Access Compliance Report Public Rights-of-Way (Curb Ramps)

Main Street: REATA_RD		Cross Street: RIBERA_RD		Location:	S
ADA ID: RPRK211118131918	Ramp Type:Type 1 - Perpendicular	Initial Pass/Fail: Fail	Overall Compliance: No	Severity Score:	16
Codes/Mitigation Info/Possible Solution			Field Measurements/Component Compliance

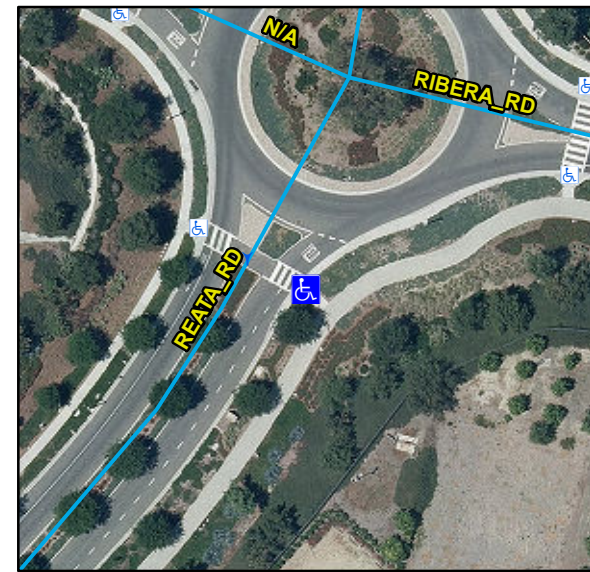
Compliance	Description	Data	Compliance	Description	Data
N/A	Ramp Length (in)	60	N/A	Flare Type LT	
Yes	Ramp Width (in)	60			N/A
No	Ramp Run Slope (%)	9.5	N/A	Flare Slope LT (%)	N/A
No	Ramp Cross Slope (%)	3.7	N/A	Flare Traversable LT	N/A
N/A	Landing Present	N/A	N/A	Flare Type RT	
N/A	Landing Length (in)	N/A			N/A
N/A	Landing Width (in)	N/A	N/A	Flare Slope RT (%)	N/A
N/A	Landing Run Slope (%)	N/A	N/A	Flare Traversable RT	N/A
N/A	Landing Cross Slope (%)	N/A	N/A	DWS Provided	N/A
N/A	Landing Movement Obstructed?	N/A	N/A	DWS Contrast	N/A
	Landing Movement Type	N/A	N/A	DWS Length (in)	N/A
N/A	Landing Shared	N/A	N/A	DWS Full Width	N/A
N/A	Clear Space	N/A	N/A	DWS Offset Left (in)	N/A
N/A	Clear Space To Crosswalk (in)	N/A	N/A	DWS Offset Right (in)	N/A
N/A	Marked Crosswalk 1	Yes	N/A	Marked Crosswalk 2	N/A
	Crossing 1 Direction	NW		Crossing 2 Direction	N/A
	Marked Crosswalk 1 Width (in)	144		Marked Crosswalk 2 Width (in)	N/A

N/A	Ramp Inside Crosswalk 1	Yes	Yes	Ramp Inside Crosswalk 2	N/A
	Crossing 1 Slope (%)	4.5		Crossing 2 Slope (%)	N/A
	Crossing 1 Cross Slope (%)	3.1		Crossing 2 Cross Slope (%)	N/A
N/A	Gutter Ponding	N/A	N/A	Curb Slope	4.4
Yes	Gutter Lip Height (in)	0		Road Run Slope (%)	N/A
N/A	Gutter Run Slope (%)	N/A		Road Cross Slope (%)	N/A
N/A	Gutter Cross Slope (%)	N/A			
Yes	Overall Surface Condition: Acceptable		Yes	Perp Joint Present	Yes
	Cross Gutter Present?	No		Spandrel Present?	No
	Replace Cross Gutter?	N/A		Replace Spandrel?	N/A

Remove & Replace Entire Ramp.

R304.2.2, R304.5.3, STD 1115
